Comments for Namoi Water on Vickery Extension Project EIS Groundwater Assessment

By Andrea Broughton, Gradient Ltd (trading as Groundwater Solutions International)

1.0 Introduction and Scope of Works

Figure 1

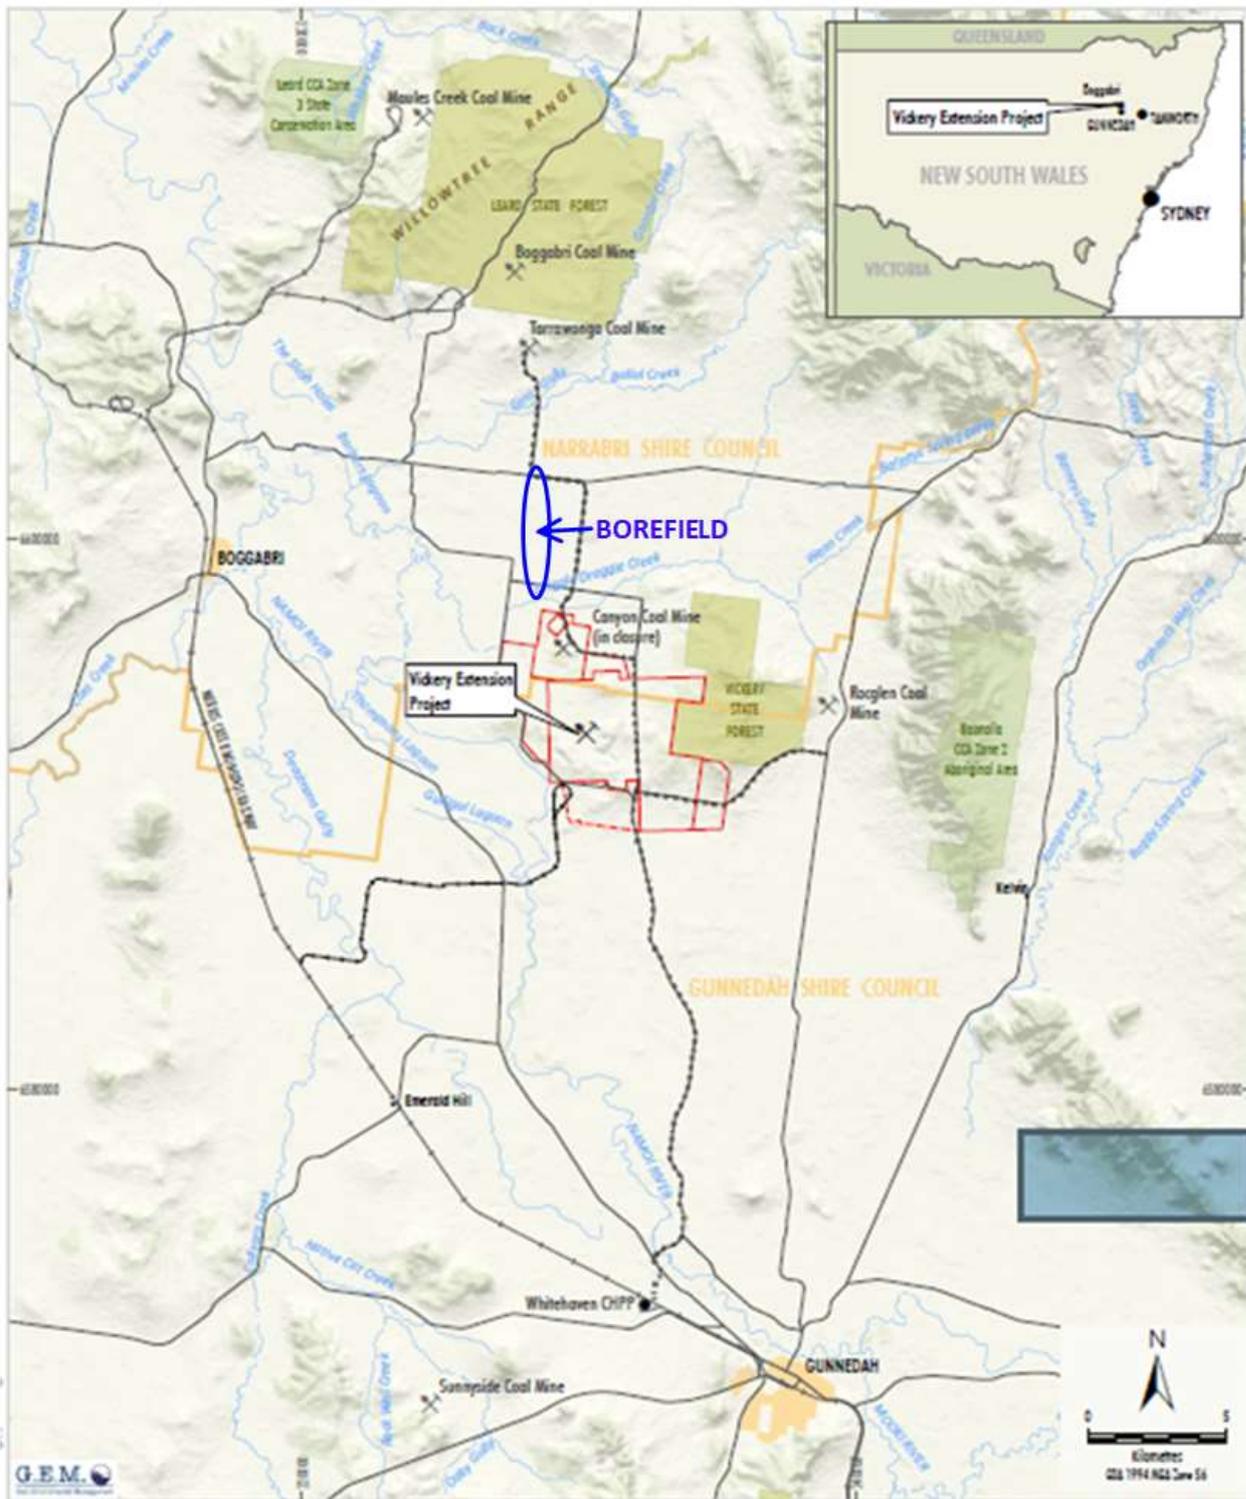
Figure 1 shows the location of the Vickery Extension Mine (the Project) and the proposed water supply borefield consisting of 10 bores (Figure 1 is annotated by GSI). The location of the mine within Upper Namoi Zone 4 and the mine layout is presented in Figures 1 and 2 of HS GA (2018).

Figure 49 Simulated Pit Inflows at All Mines from 2012 to 2044

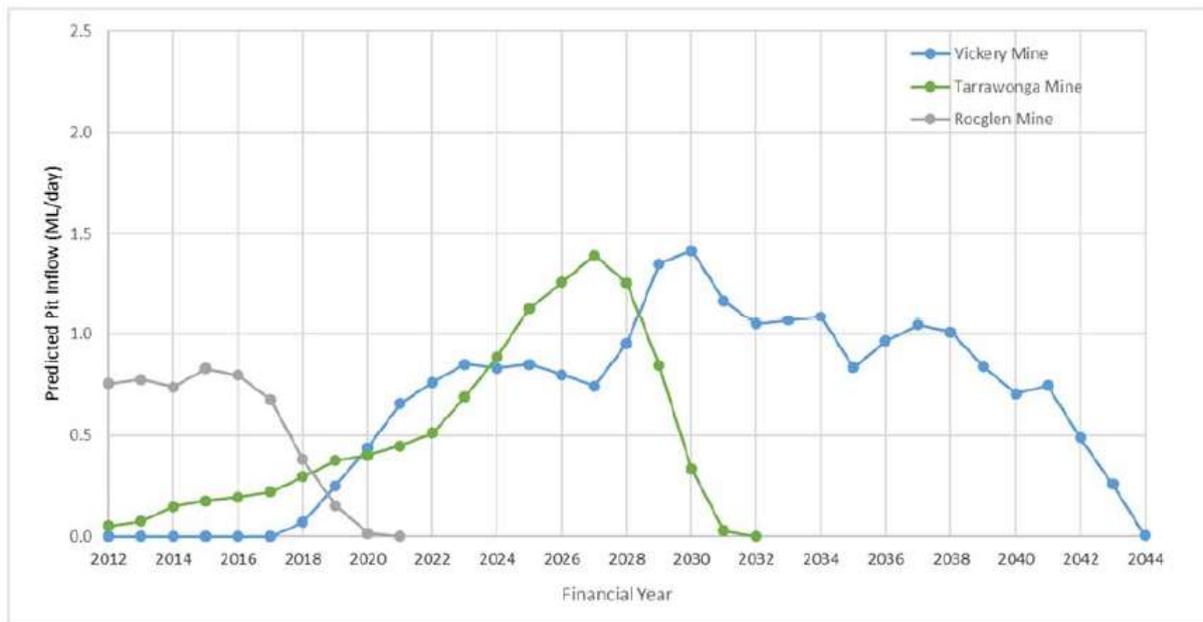
The Project has enough licenses to account for groundwater usage during the mining and post-mining phase of the project, if Figure 49 below is accurate. This is assuming the model hydraulic conductivities for the coal seams and alluvium are representative. The hydraulic conductivities used in the modelling will affect the computed seepage/inflows from the coal seams into the mine pit and the induced drawdown in the alluvium into the porous rock which will ultimately end up flowing into the mine pit. A full PEST sensitivity and a Monte Carlo uncertainty analysis would have investigated whether the modelled inflows are realistic.
